Added information: Solution for bigger screens not to make the screen slope left and right:

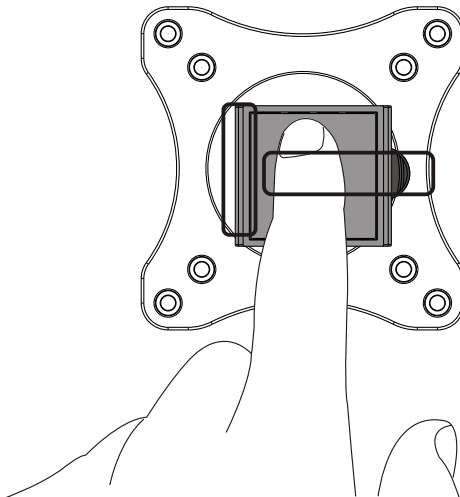
Don't make the gap on plastic part and gap on vesa plate vertical. Make them horizontal.
